# CITY OF ALBUQUERQUE

**RE: Carlisle Marketplace  
2100 Carlisle NE  
Conceptual Grading Plan Stamp Date: 12/3/19  
Drainage Report Stamp Date: 12/3/19  
Hydrology File: H17D097**

# DRAINAGE REPORT FOR CARLISLE MARKETPLACE

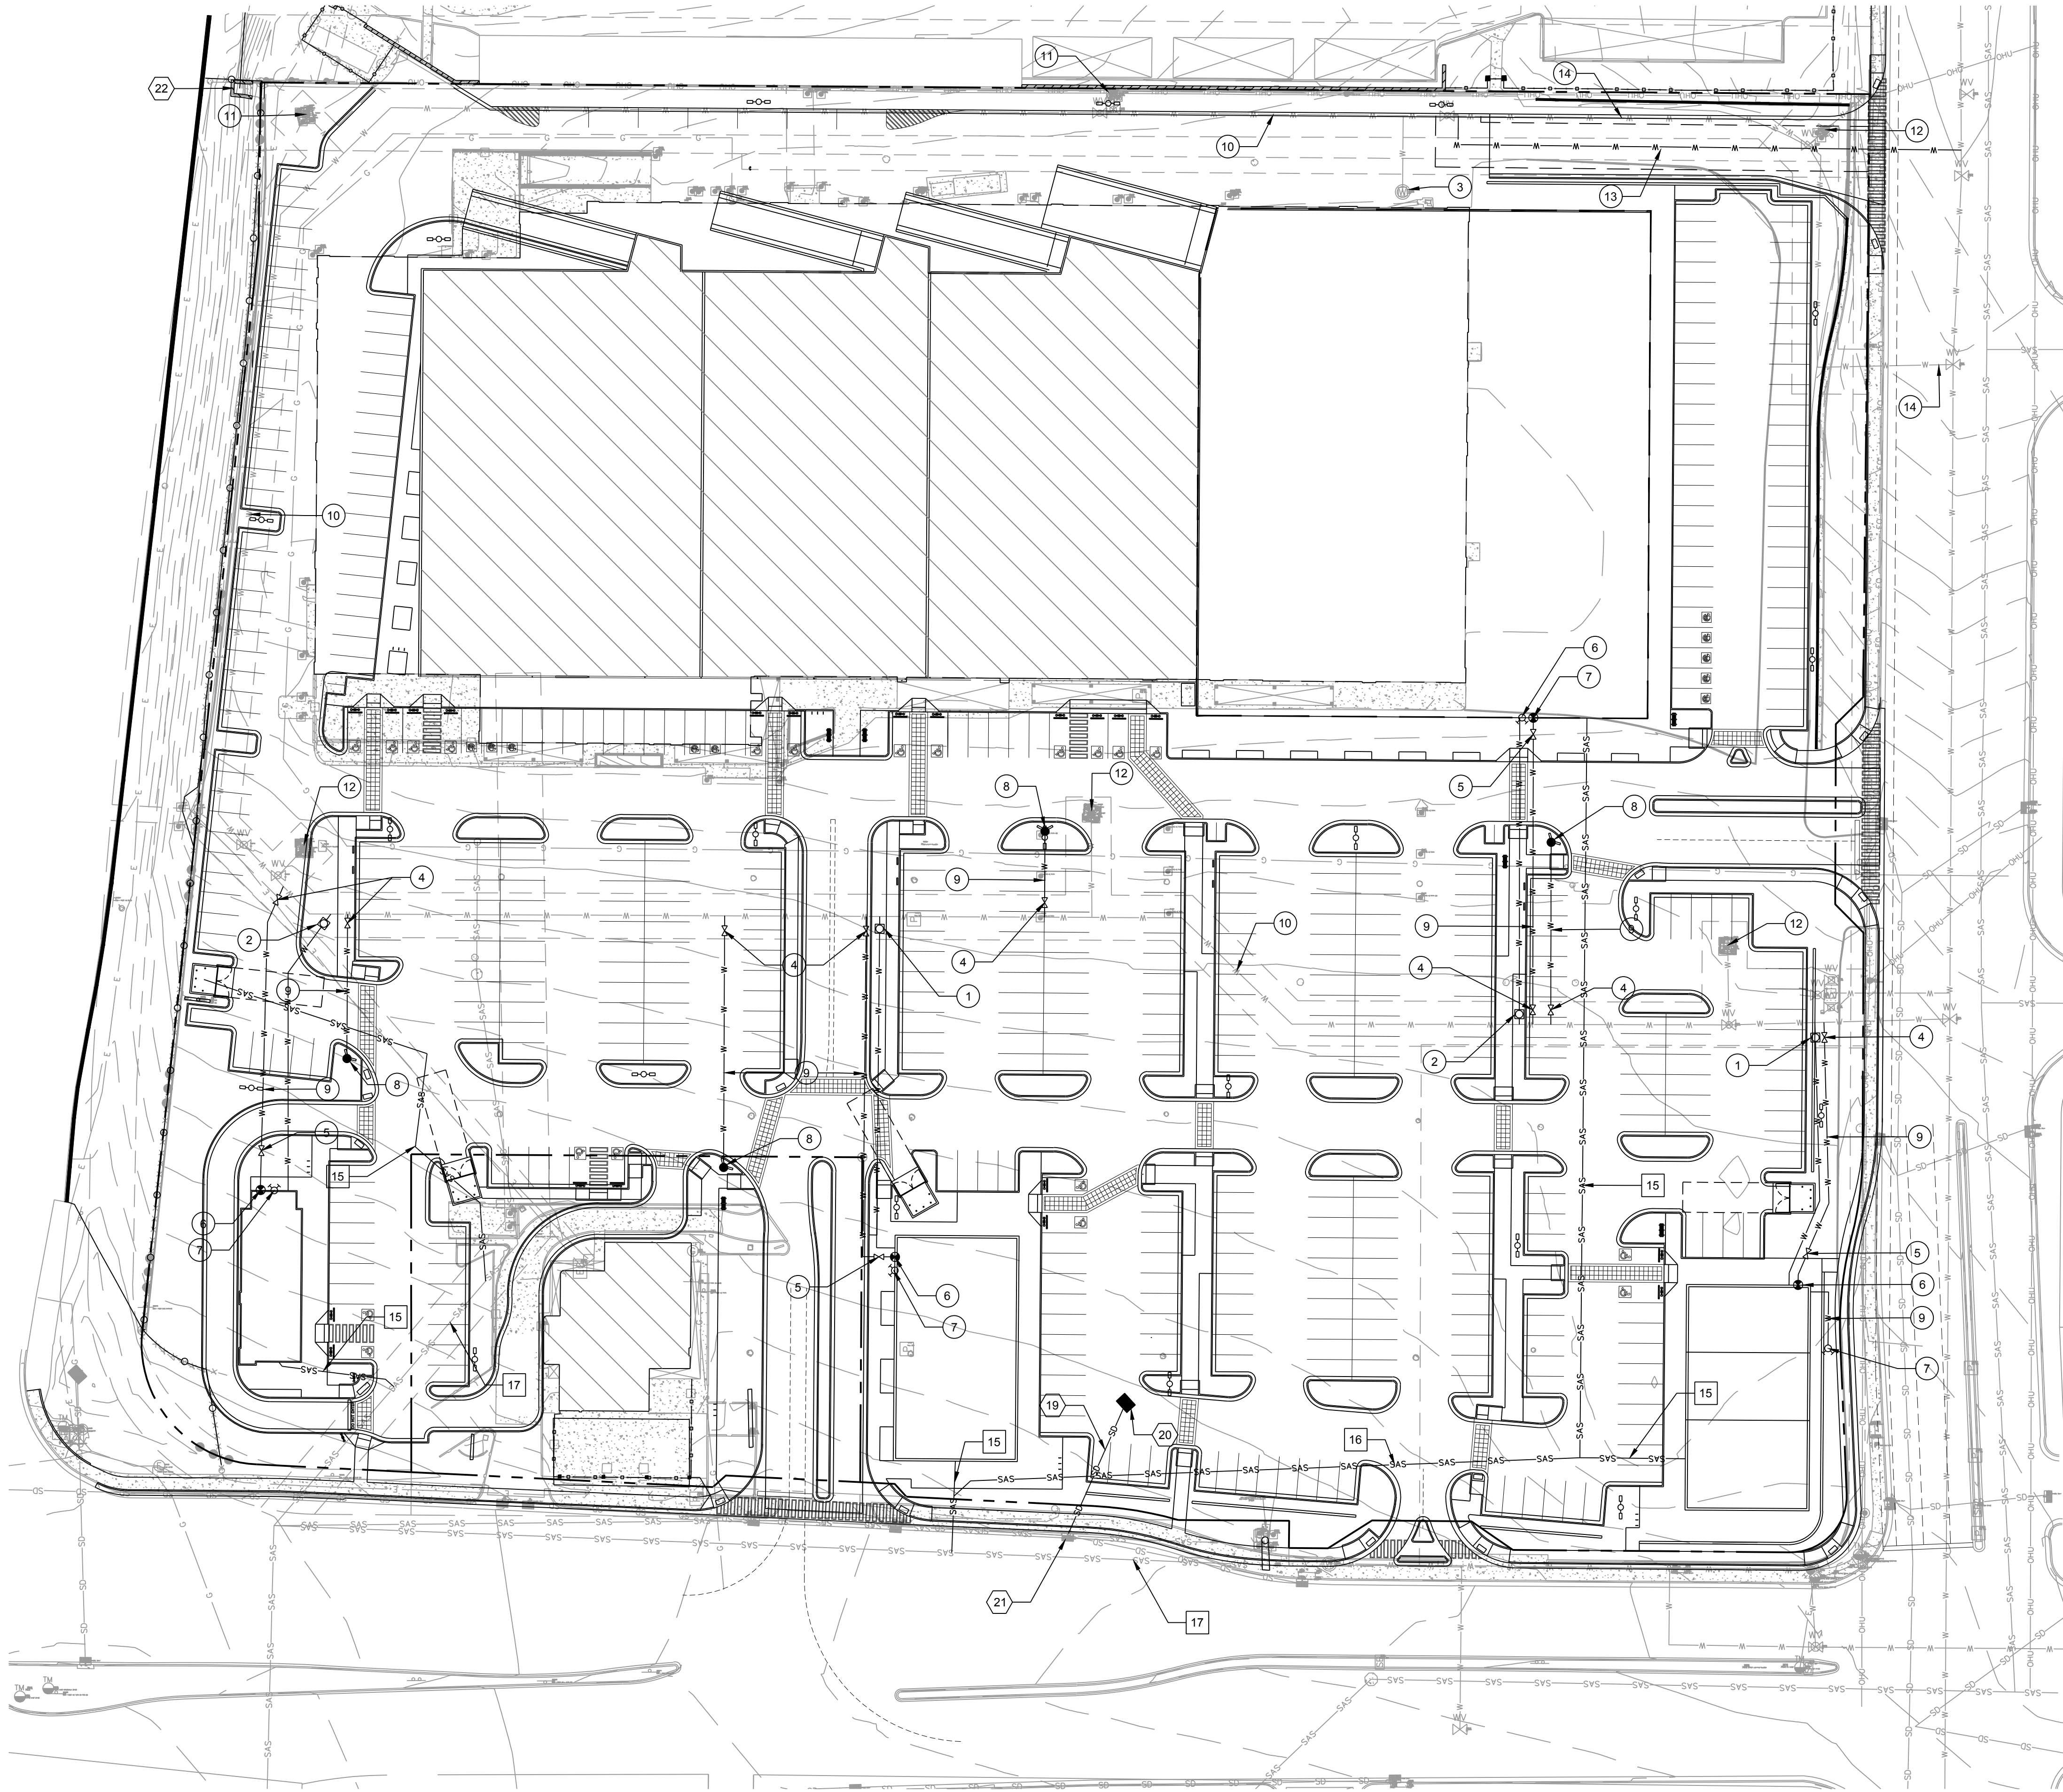
Additionally, keyed note 19 on sheet C-300 proposes a storm drain pipe at the existing inlet/rundown at the northeast corner of the property.

If this approach is agreeable to you, I will update the drainage report accordingly. Please let me know and I will send you a revised report. And in regards to keyed note #19, that is an error. I will fix that and resend as well.

PROPOSED SUB-BASINS

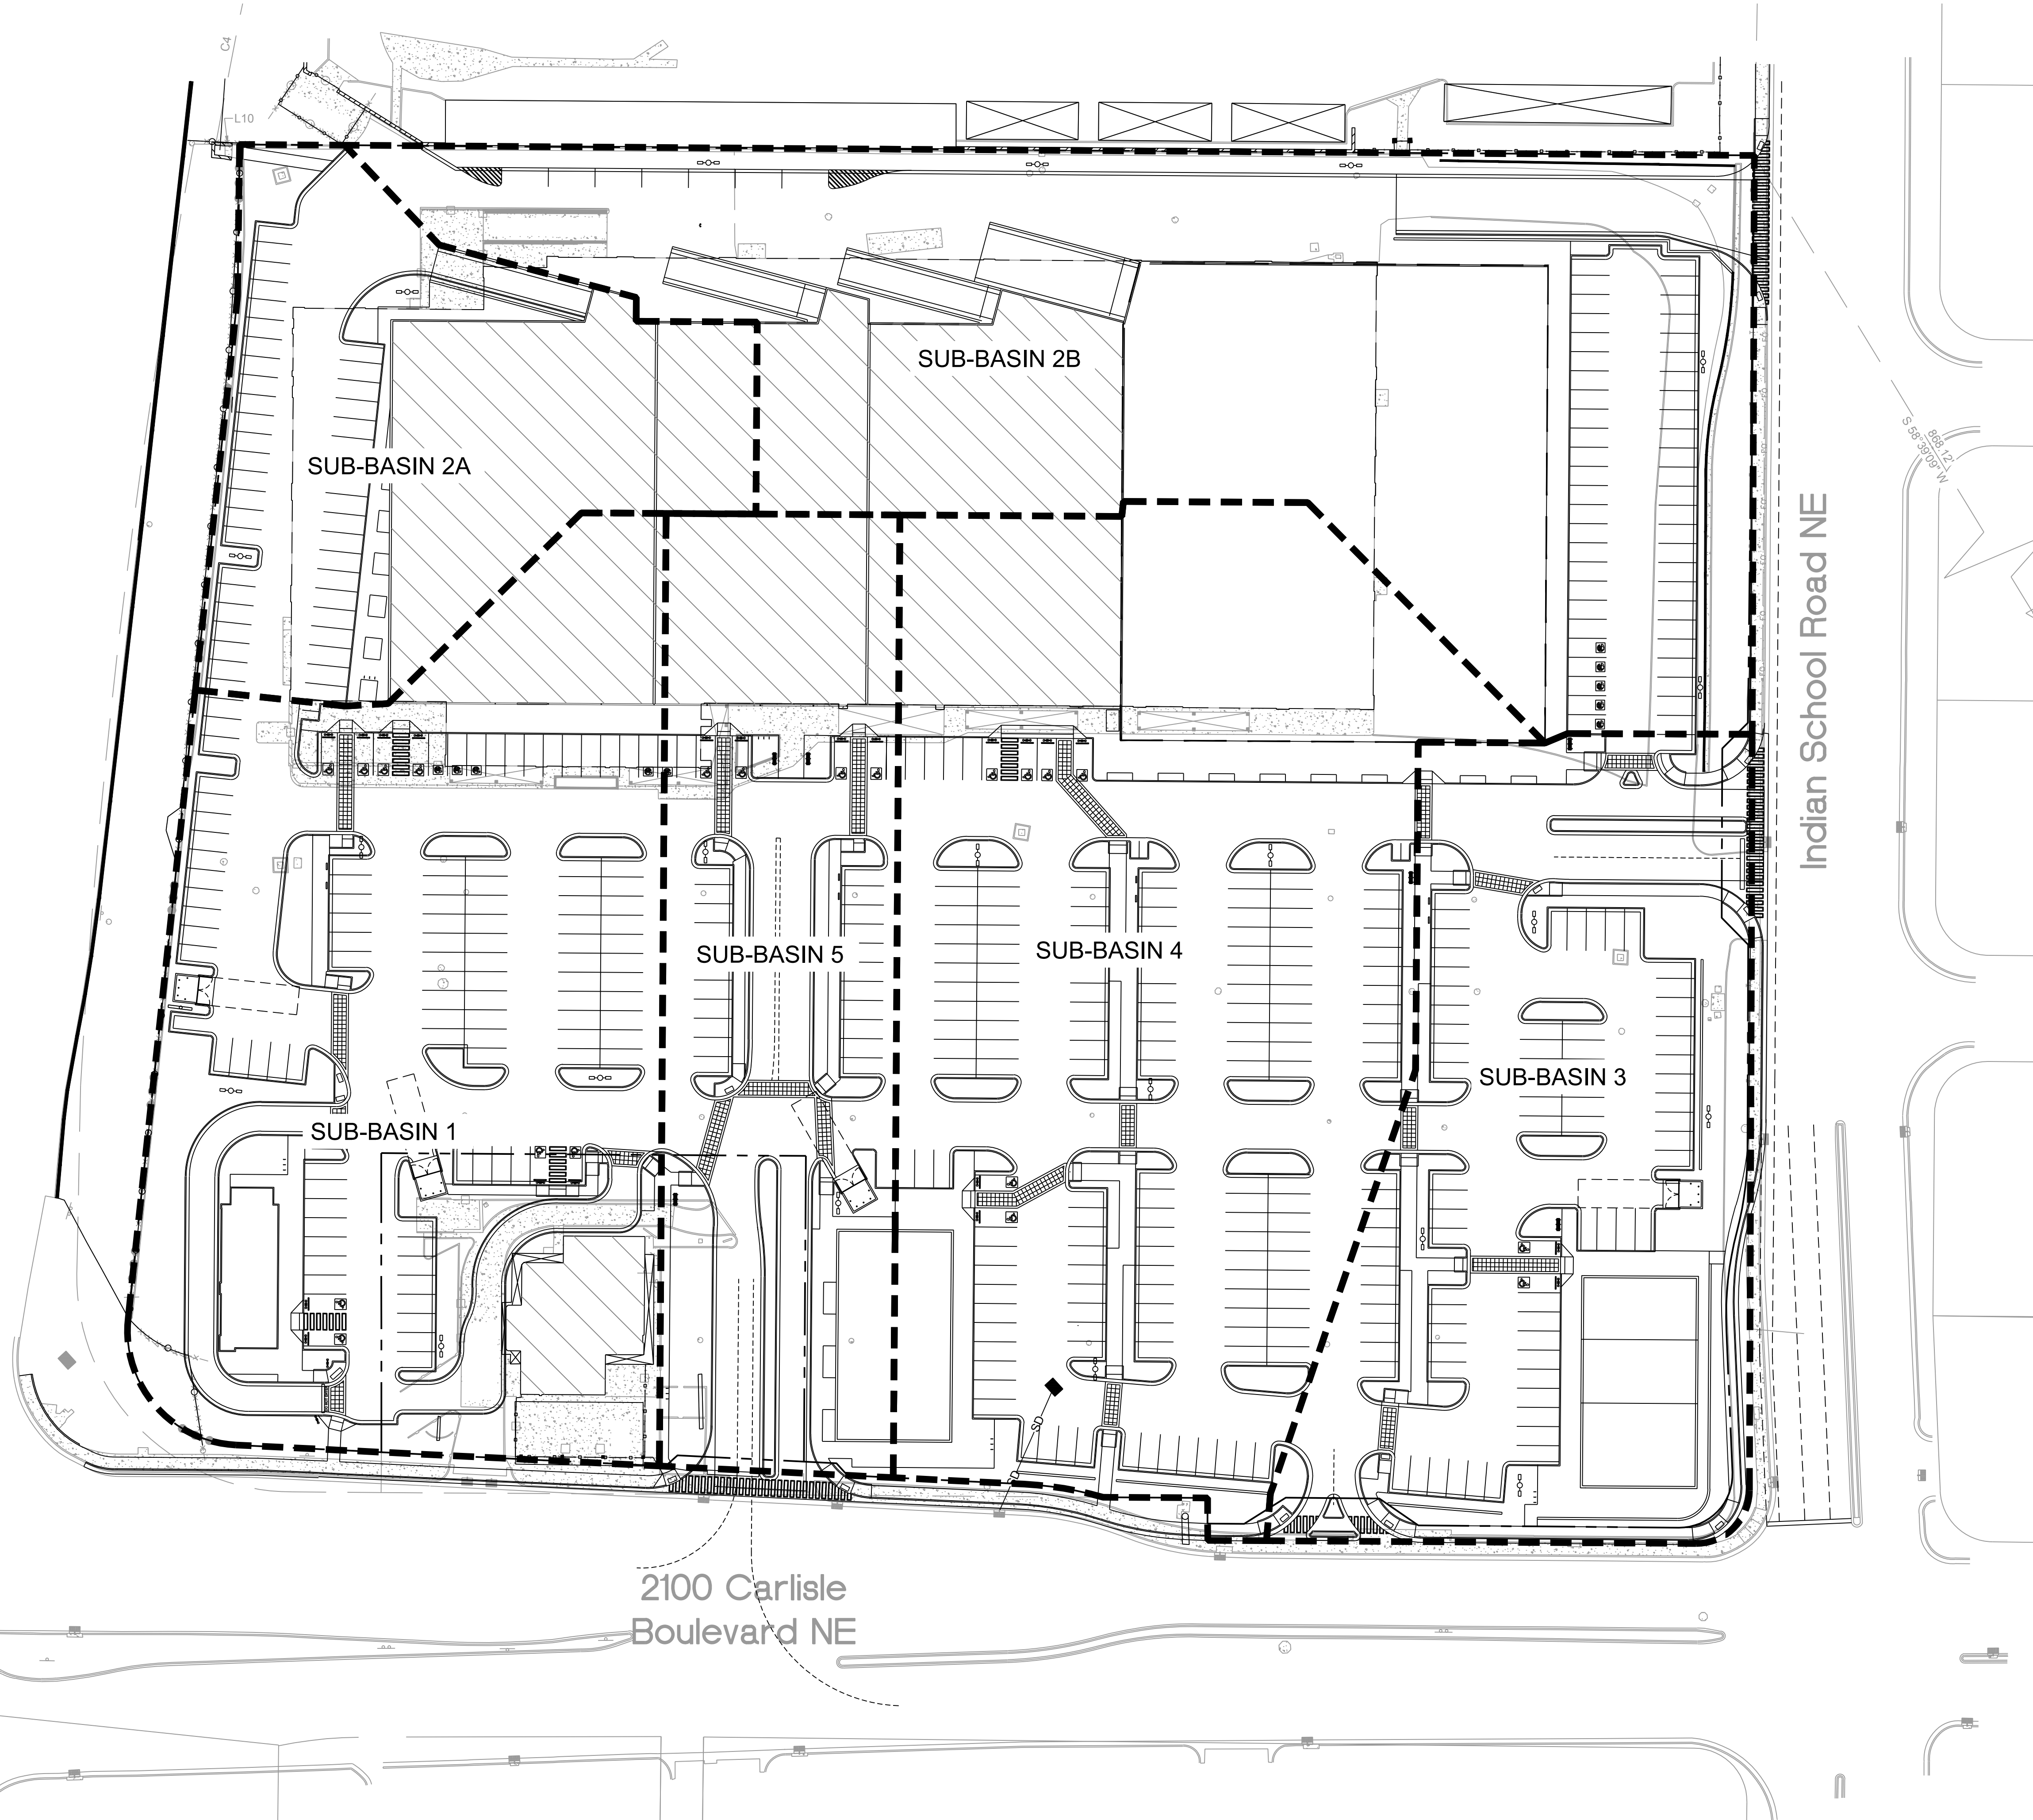
In the existing conditions the Drainage Report states that the wall opening allows runoff to discharge into the adjacent property east of Sub-basin C and subsequent flows bypass the opening entering Sub-basin B.

The proposed conditions cutoff discharge to the adjacent property. Given the size of the opening and the existing Sub-Basin C primarily sloping to the east, the majority of runoff would discharge to the adjacent property prior to bypass flow occurring. Cutting off discharge to the property would result in substantially more runoff reaching the rundown/inlet north of proposed Sub-basin 2. To the best of my knowledge the rundown and inlet are under NMDOT jurisdiction. If you have contrary information please provide it.

The existing conditions and the delineation of Sub-basin B indicate that the rundown and inlet should be limited to a discharge of 4.5 cfs.

Please indicate how runoff would be mitigated to existing conditions or provide information that the rundown and inlet are not under NMDOT jurisdiction.

Upon further review, I agree that flows should not be cutoff to the east. I have analyzed the existing conditions and have come to the following conclusion. See attached. Flows coming from Sub-basin C enter this area and collect to a low point in front of the dumpster. Once that low point fills up, water begins to spill both to the east and north due to the elevation being the same on either side of the low-point area. It is difficult to discern exactly how much flow goes in each direction, but I believe a reasonable assumption is an even split.

For the developed condition, I would propose to leave this area as is and not modify the existing grades in front of the dumpster, which will allow runoff to match the existing drainage pattern at this location. By doing this, the drainage area currently discharging to the existing inlet will not be increased with this development. Nor will the discharge be increased to the adjacent property to the east. Additionally, the wall opening is located on the adjacent property, which makes it difficult to modify the drainage regardless.
